U. S. ATOMIC ENERGY COMMISSION  
REGION I  
DIVISION OF COMPLIANCE

Report of Inspection

CO Report No. 219/71-1

Licensee: JERSEY CENTRAL POWER & LIGHT COMPANY  
Oyster Creek - 1  
License No. DPR-16  
Category C

Figure 1 Floor Drain Concentration Vs Stack Gas Rate

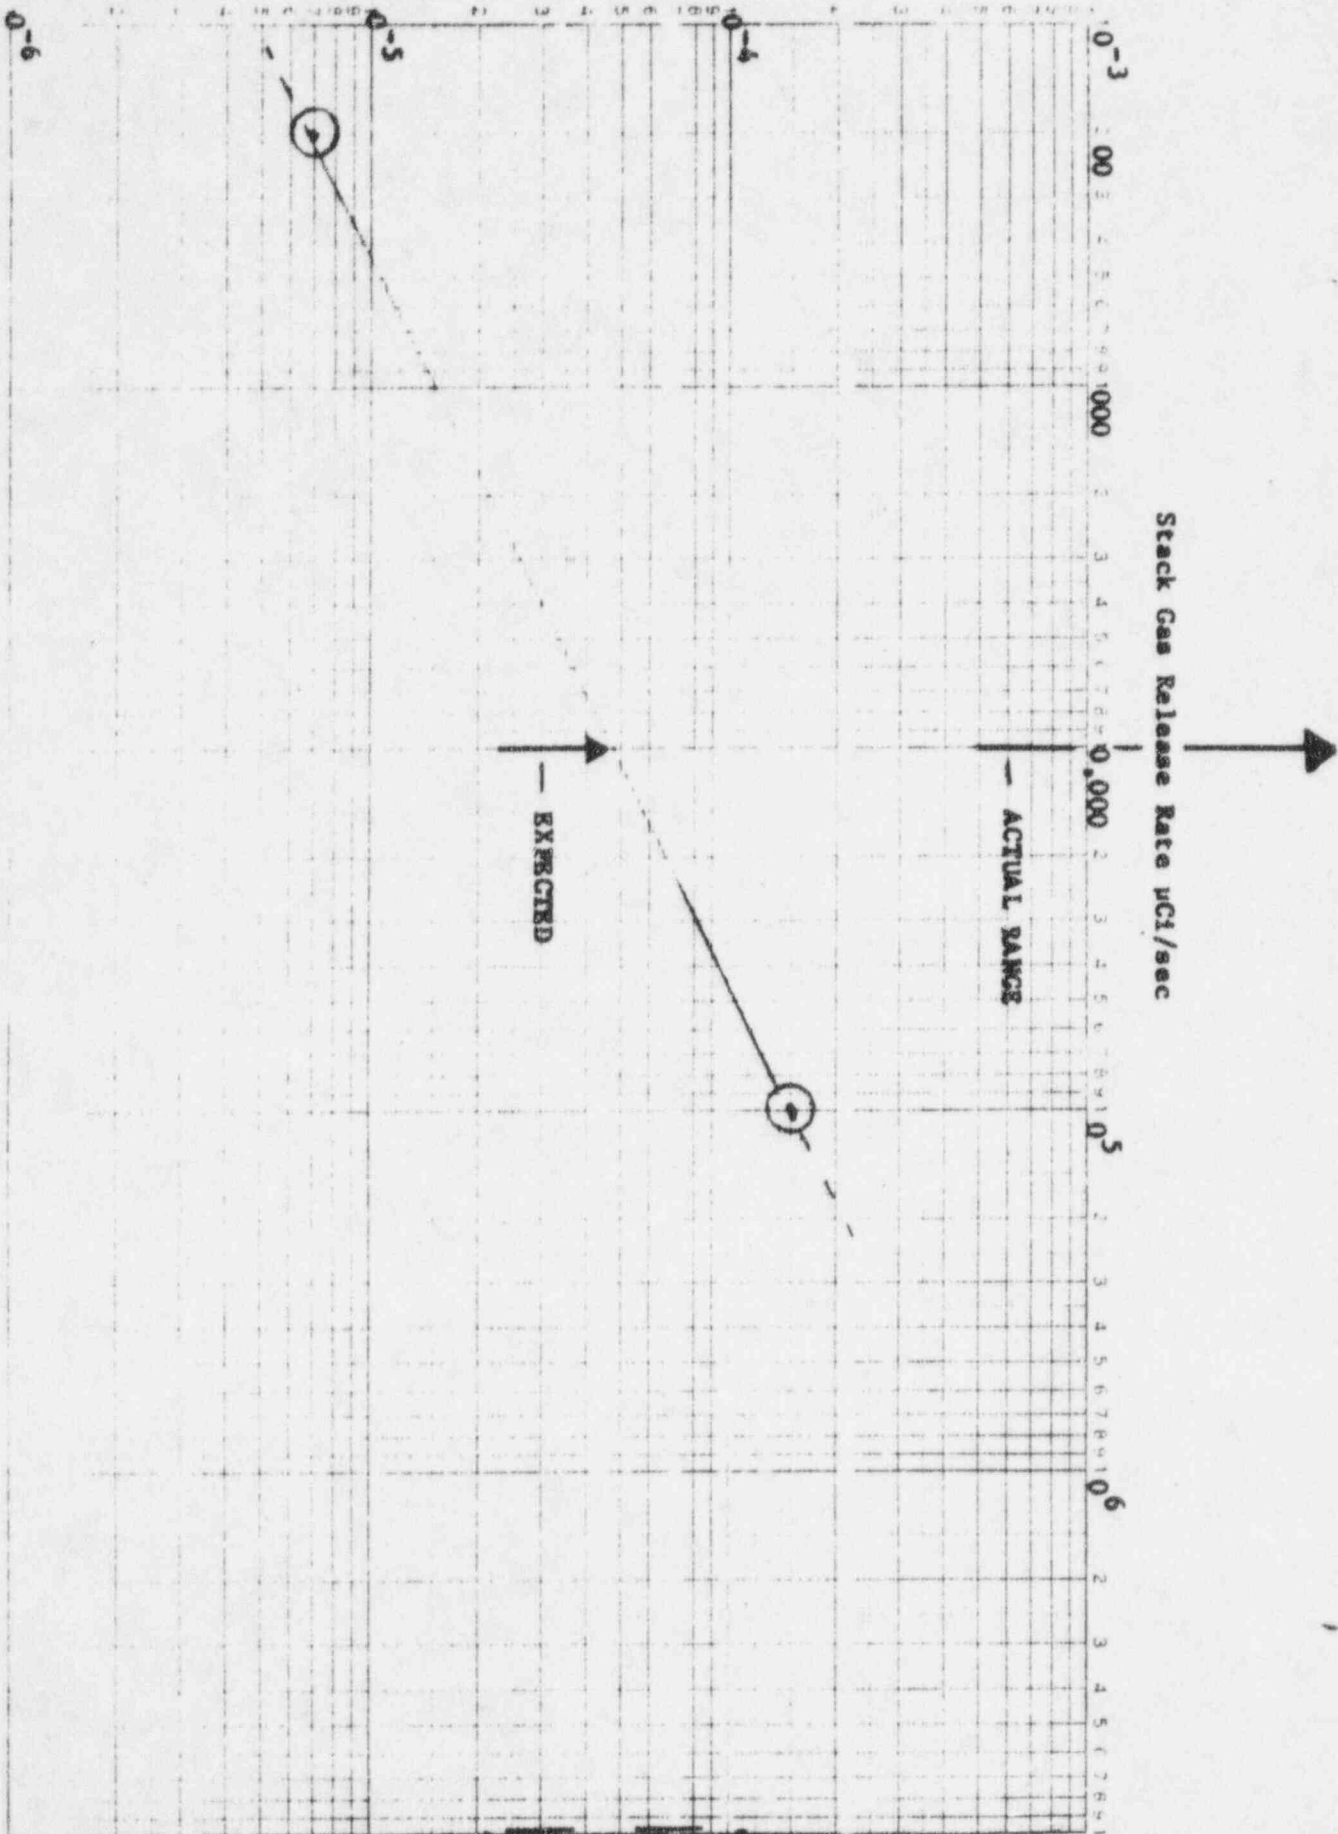
rate of 10,000 uCi/second (which is typical of station performance for December, 1970 to March, 1971) indicates that the expected floor drain concentration is  $0.5 \times 10^{-4}$  uCi/ml. Actual concentrations range from 10 to  $50 \times 10^{-4}$  uCi/ml or 20 to 100 times the expected value.
